Thread Engagement in Fixture

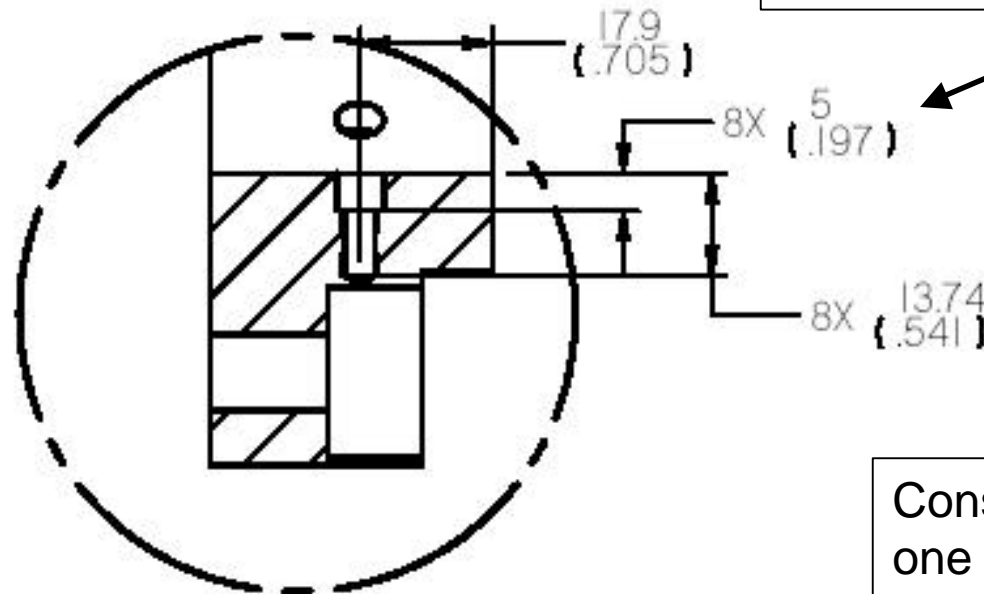
Counter-bore depth was increased but neither the length of the bolt nor the flexure dimensions were changed to preserve original design length of thread engagement

Consequently, as little as one D of threads were engaged, increasing the risk of joint failure
